8TH STREET COMMUNITY CORNER

EXTERIOR RENDERING SKETCH

PLANNING CLEARANCE APPLICATION

From: dabpe <dabpe@peak.org>
Sent: Thursday, November 18, 2021 8:37 PM
To: coastalkathy@peak.org
Subject: Fwd: RE: Plans submitted on 11/03. 8th St COMMUNITY CORNER, aka 740 Oregon Street. Port Orford.

FLOOR PLAN | OBSERVATION FLOOR

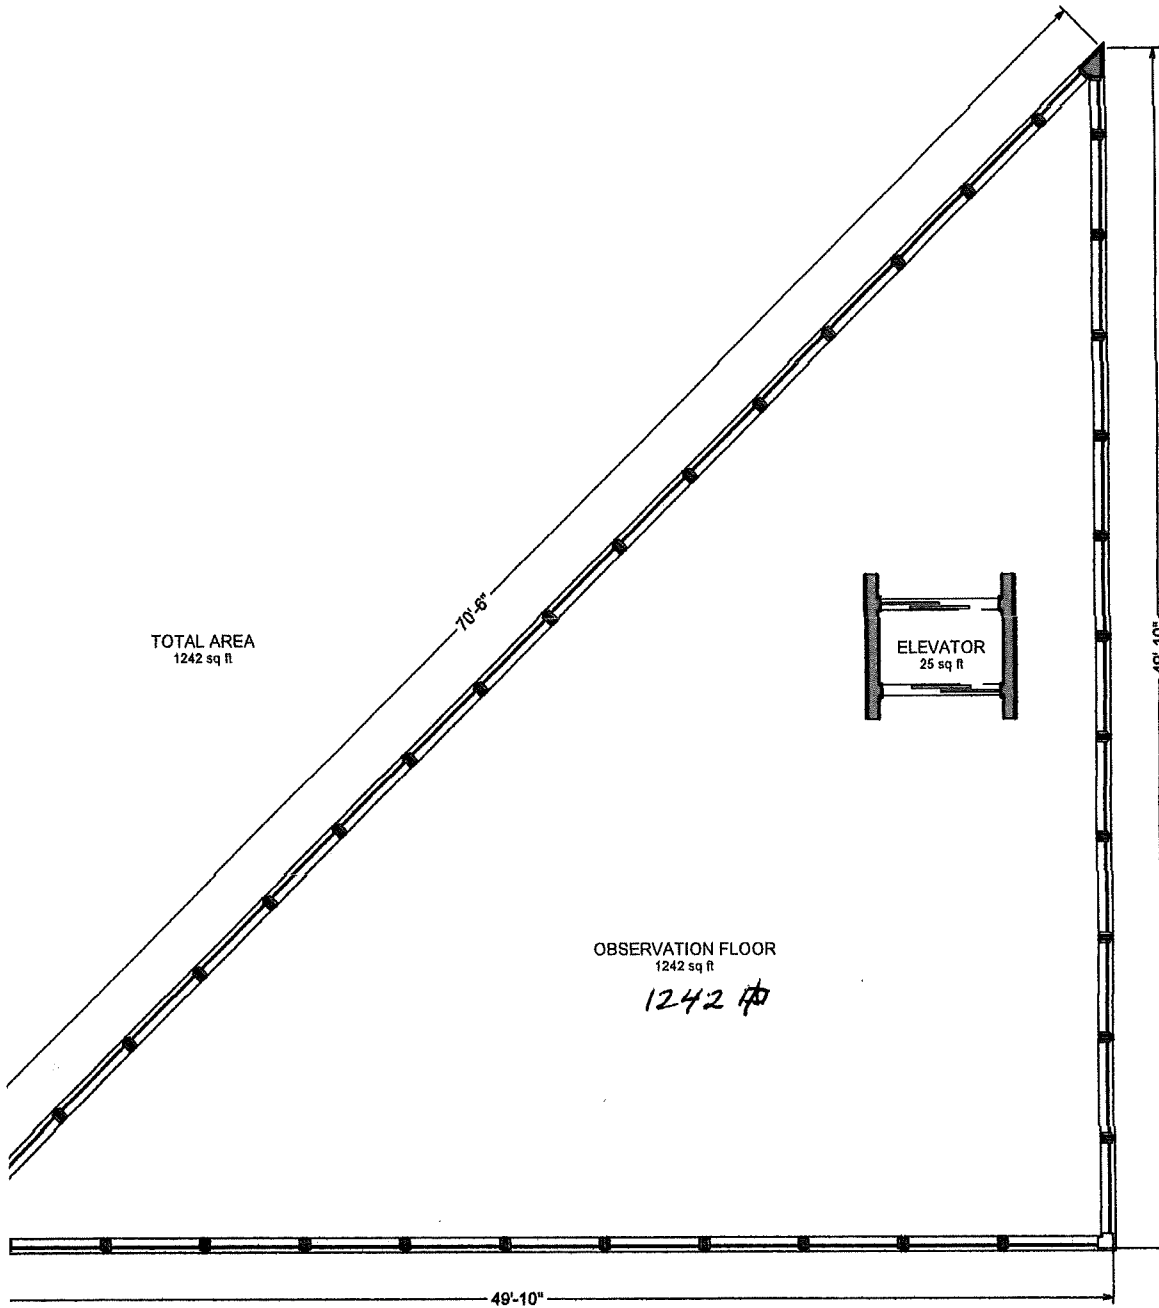
- 1) We need the sign off from Coos Curry Electric
- 2) The definition of a building is a structure built for the support, shelter or enclosure of persons, animals, chattels or property of any kind. On the forms we received the "tower" fits all the

definition of Building. Need Clarification on it being an Observation Tower. And if It is an observation tower than it possibly could NOT be a restaurant in the future.

Q#2. Page 17 of the submittal shows a 1242 sq ft isosceles right triangular room with an elevator / stair location and is an observation tower for 49 persons MAX occupant load per OSSC. I have no plans for it to be anything but an observation tower..... which I may choose to build to a Tsunami Evacuation standard as outlined in Q#4 below. Why would you be opposed to me saving lives when the seismic subduction event could occur at any time? Running up Coast Guard Hill with the flood coming from your fractured water tank is unrealistic.

SW ELEVATION

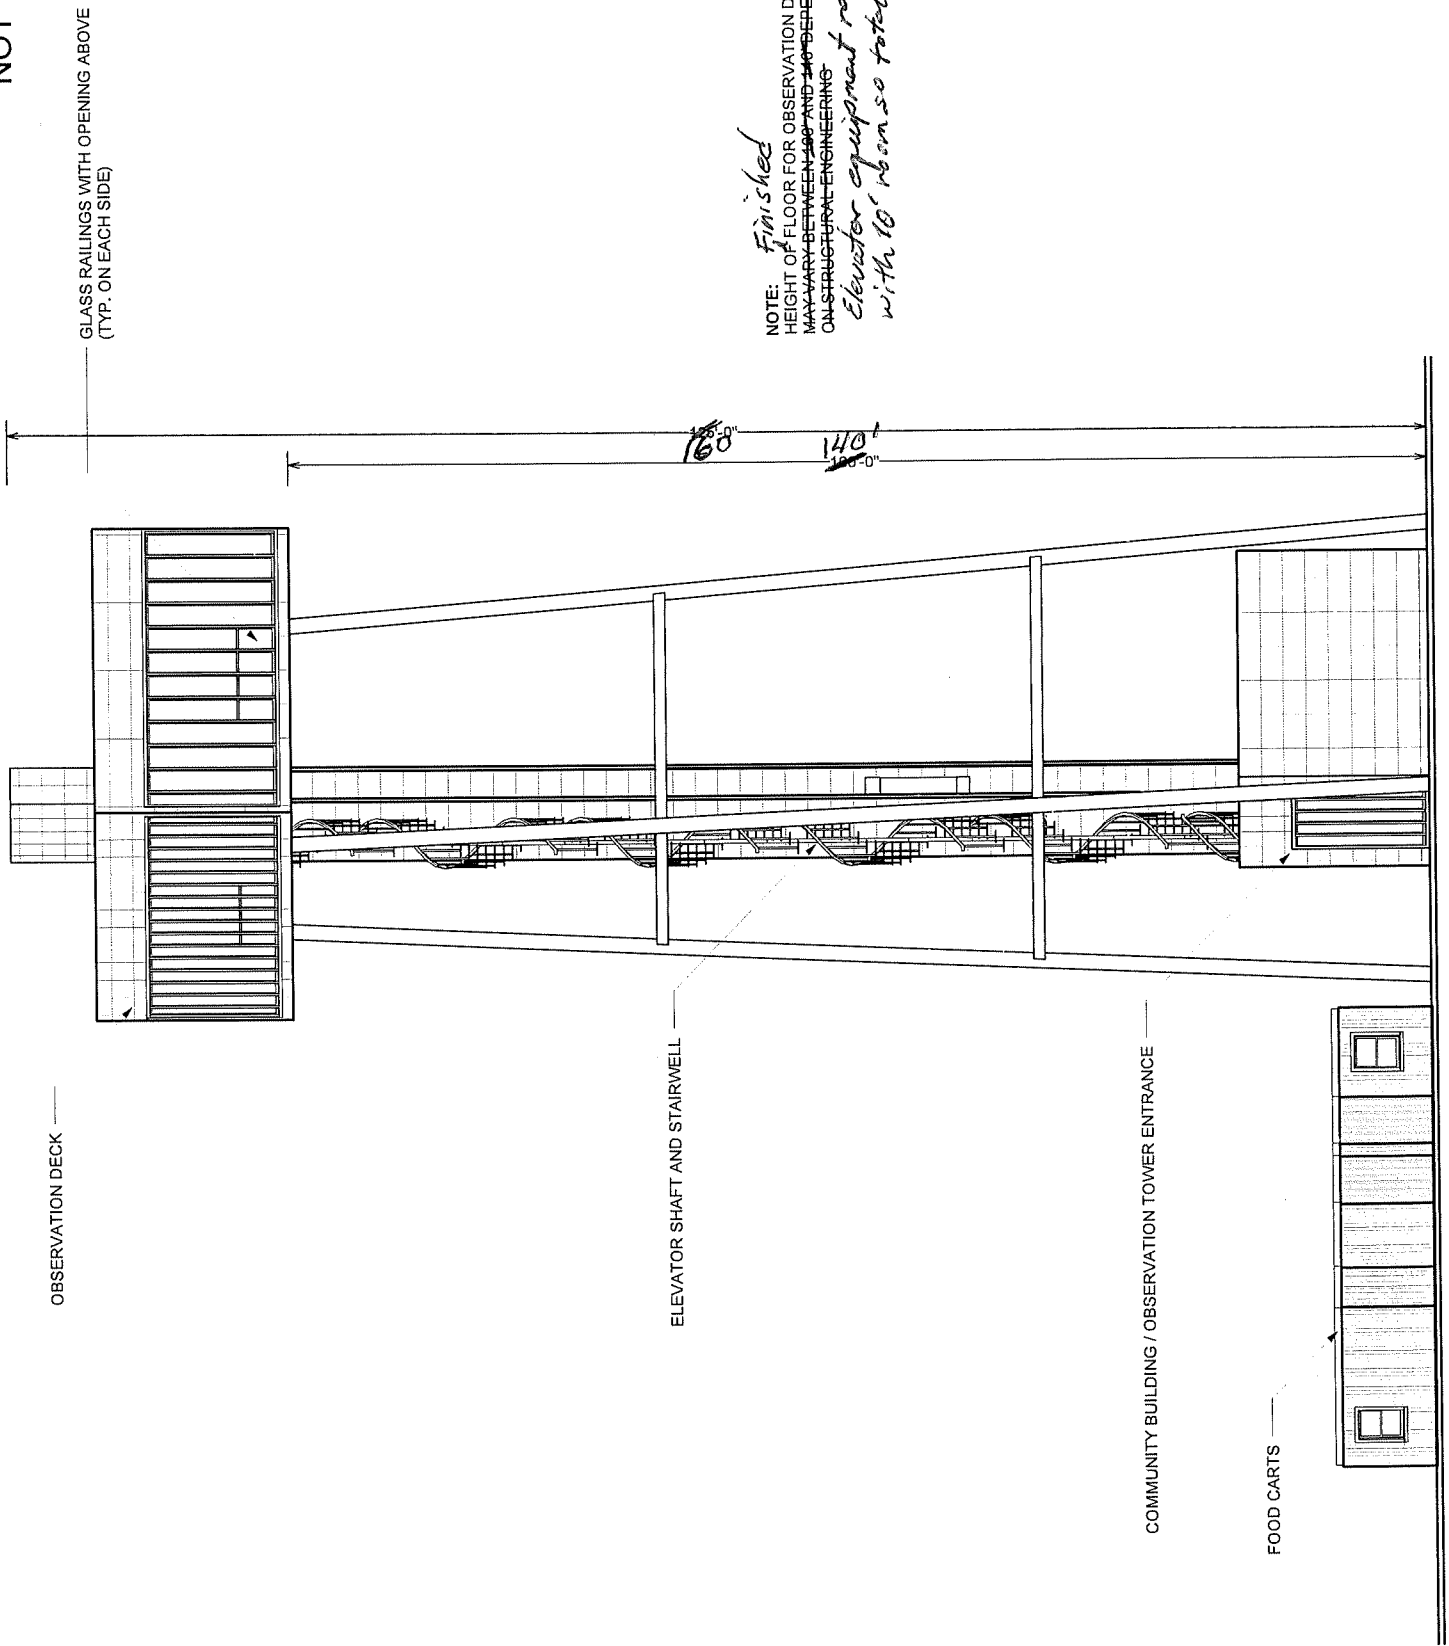
- 3) Need to know what the height of the tower is. The height is not referenced on your plans that were submitted to us.
- 4) Tsunami Evacuation Tower can NOT be listed as a use. There is another set of laws set forth by the State of how Tsunami Evacuation Towers need to be constructed.
- 5) We also do not see any lights on the plans and we want to make sure that it sticks to the new Dark Sky's Ordinance that was passed.

NOTE: *Finished*
HEIGHT OF FLOOR FOR OBSERVATION DECK @ 140'
MAY VARY BETWEEN 100' AND 140' DEPENDING
ON STRUCTURAL ENGINEERING
*Elevator equipment room approx 10' high
with 16' clear so total to top = 160'*

Q#3. The drone footage shows the best views at approx 150 ft agl. Planning the finished floor level at 140 ft utilizes standard cell tower technology like the site I own in Josephine County with a 140 ft galvanized steel lattice tower with AT&T, USCellular and T-Mobile cell services. Before West Coast contractors built it in the 90's, I was concerned about the appearance on the easterly ridge of my ranch, but soon learned from vIsiting every cell site in S Oregon that you have to know exactly where to look for the tower to even be seen against the sky at all hours of the day. Today, if you really work at seeing it coming down Hayes Hill, you might catch a quick qlimpse and then it is not at all visable. On the 8TH ST COMMUNITY CORNER, the open tower, with the small room at the top will not be very noticeable from 101..... or anywhere else.... except to the kids, who will want to go up and see the sights. My first trip to the space needle in Seattle was in 1962 for the

The soil bearing bore hole tests our Geo Tech team will perform soon will firm up the projected height and that is why the height was not yet specifically shown on the elevations.
